APPLICATION NO.	FILING DATE	FIRST NAMED INVENTOR	ATTORNEY DOCKET NO.	CONFIRMATION NO.
09/347,845	09/30/1999	YI YANG	243/079	4401

Office Action Summary

DETAILED ACTION

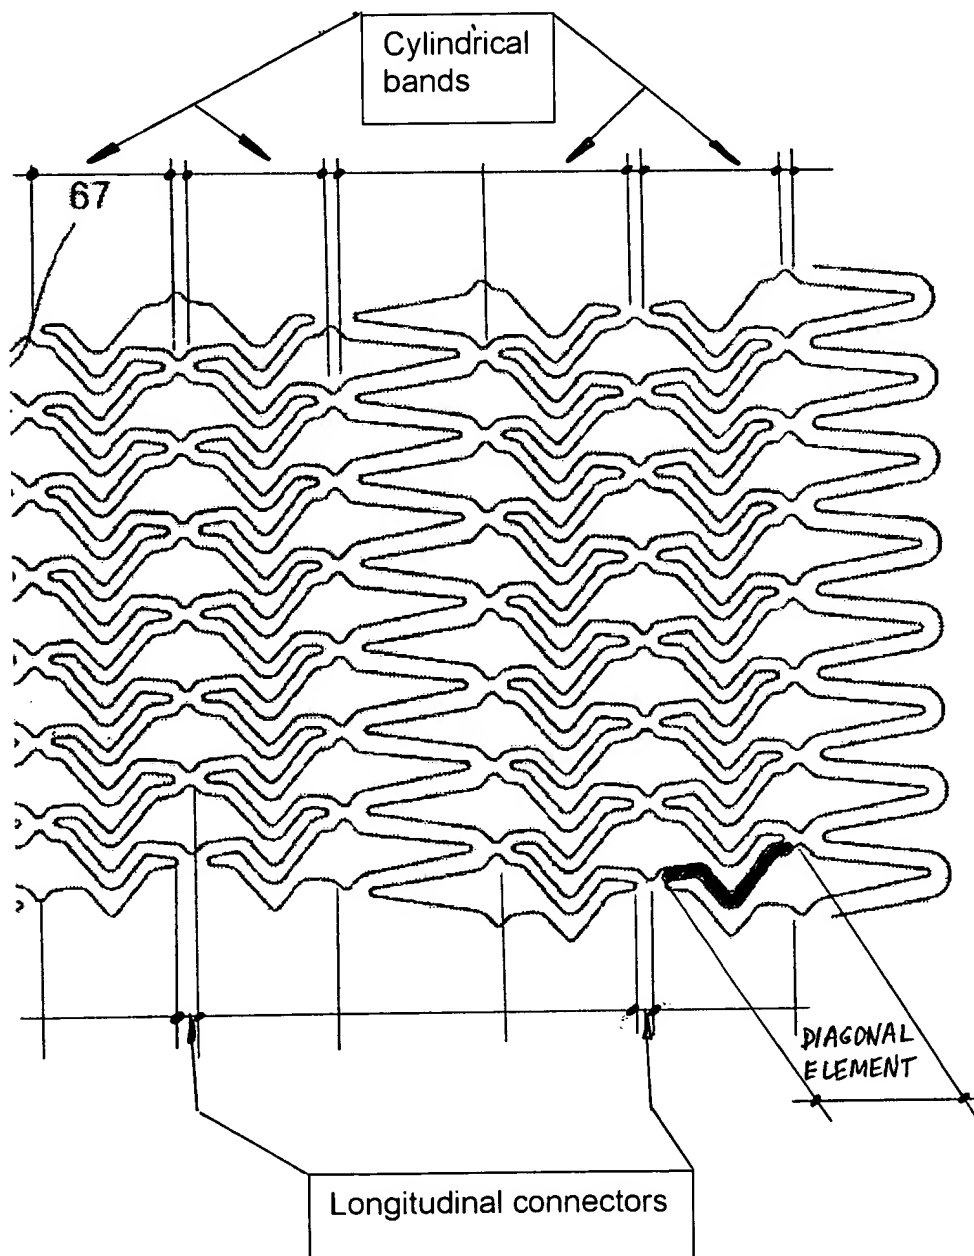
2. Claims 1, 3-4, 8-15, 17-22 and 24-25 are rejected under 35 U.S.C. 102(e) as being anticipated by VON OEPEN (6,193,747).

As to claims 1, 3-4, 8-11, and 24-25, VON OEPEN (Fig. 8 as copied and shown below; column 1, lines 36-39) discloses a **non-sinusoidal** zigzag pattern tubular stent (60) expandable from a contracted condition for easy introduction of the stent into a body lumen (a blood vessel) to an enlarged condition for supporting and keeping the body lumen (the blood vessel) open. Inherently, the stent is biased towards enlarged condition from a contracted condition (as recited in claims 4, 24-25) to support the body lumen. The stent comprises:

- A plurality of cylindrical bands/more than one bands, each band comprises a generally **non-sinusoidal** zigzag pattern of diagonal elements having generally arcuate shapes, arbitrarily assigned either a clockwise or counter clockwise orientation.
- A plurality of short and **straight** longitudinal connectors (I-shaped) extending substantially parallel to the longitudinal axis of the stent.

- The longitudinal connectors have a longitudinal dimension substantially smaller than a longitudinal dimension of the diagonal elements (as recited in claim 9). The diagonal elements comprise 1st and 2nd generally straight portions having 1st ends connected to preceding and succeeding diagonal elements and 2nd ends being connected together (as recited in claim 10).
- The diagonal elements of each cylindrical band are out of phase with any adjacent cylindrical band (as recited in claim 11).

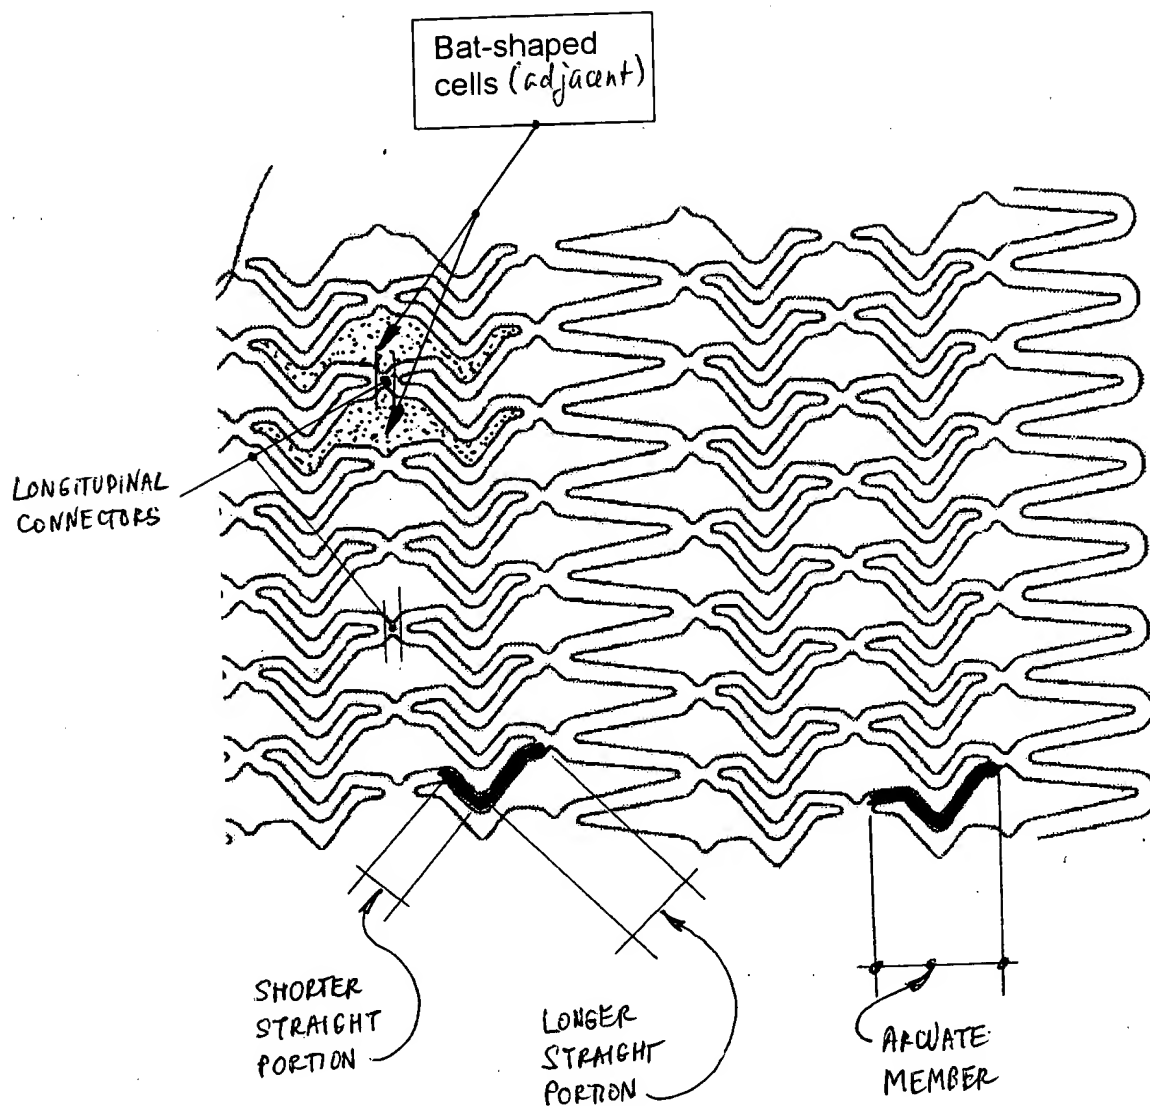
As to claims 12-15 and 17-22, VON OEPEN (Fig. 8 as copied and shown below; column 1, lines 36-39) discloses a tubular stent (60) comprising:

- A plurality of bat-shaped cells (more than one cells) formed from **non-sinusoidal** cylindrical bands each formed having a head region, a tail region, opposing curved wing regions.

- A plurality of **straight longitudinal** connectors (I-shaped) extending substantially parallel to a longitudinal axis (as recited in claims 12 and 15) and **connecting each of the** adjacent cells.

- The head and tail regions are aligned about the circumference of the stent, the wing regions have a generally V-shaped extending longitudinally away from the head and tail regions (as recited in claim 13).

- The cells are arranged sequentially about the circumference, thereby defining a cylindrical band (as recited in claim 14).
- The wing regions are defined by 1st and 2nd arcuate members, the 1st and 2nd arcuate members comprising a pair of generally straight portions connected to one another by a curved portion, and the curved portion defines an apex of the "V" shape curved wing regions, the apices all pointing substantially in a single direction (as recited in claims 17-18).

- The head regions and tail regions are defined by longitudinal connectors (I-shaped connectors), one of the straight portions of each of the first and second arcuate members is substantially shorter than the other generally straight portion of the respective arcuate member, and the longitudinal connectors define the tail region also define the head region of an adjacent cell (as recited in claims 19-21).

- The connectors comprise a longitudinal connector (V-shaped connector) extending between a wing region of a first cell and a wing region of an adjacent cell (as recited in claim 22).
